**No. 93-28**

## A. DHB Power Steering Valve (806034A1)

figure (1)

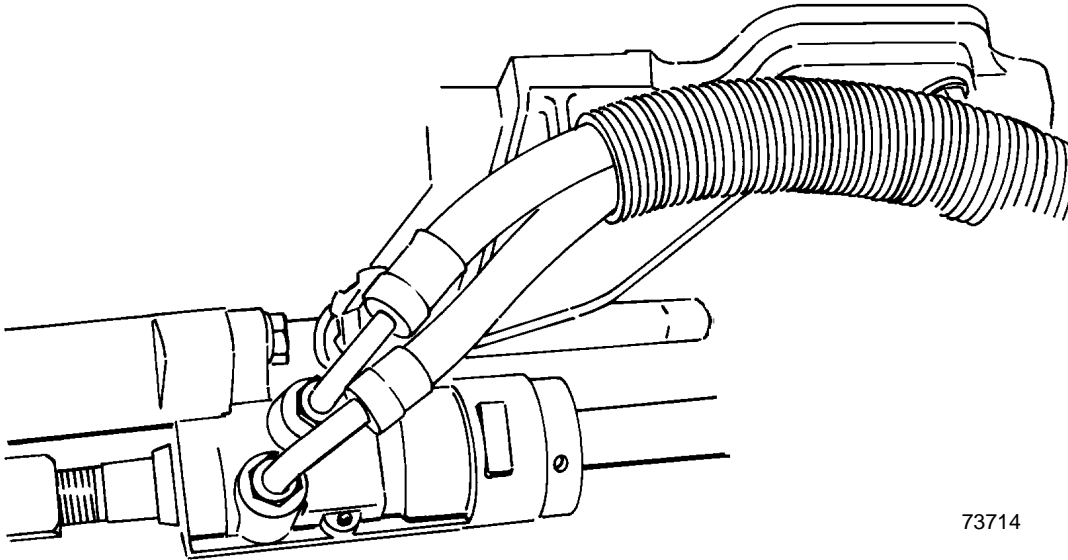
The following line drawings show the revised hose routing for the complete gasoline engine line from the 3.0LX thru the 502 EFI.

Figure 1 above is for the 4.3 L / 4.3 LX V-6 only later models.

figure (2)

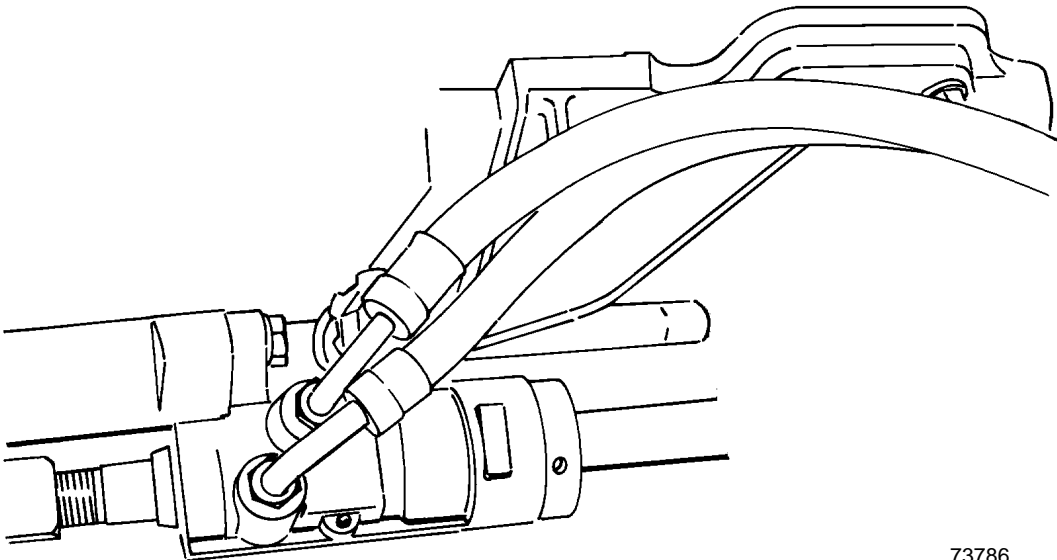
Figure 2 above is for the 3.0LX / 5.0L / 5.0LX / 5.7L 350 Magnum / 7.4L / 454 Magnum / 454 Magnum EFI, also earlier (94) 4.3L and 4.3LX and (early 502 EFI models with oil cooler return lines on the port side of the cooler).

figure (3)

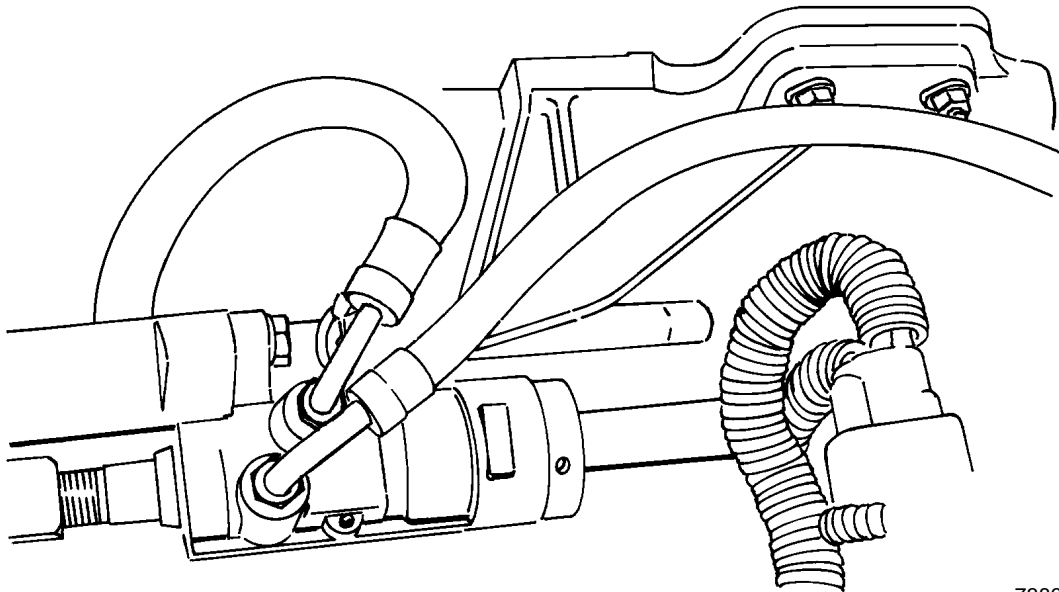
Figure 3 above is for the 502 EFI with oil cooler return lines on the starboard side of the cooler. The following chart may be used to record the values taken.
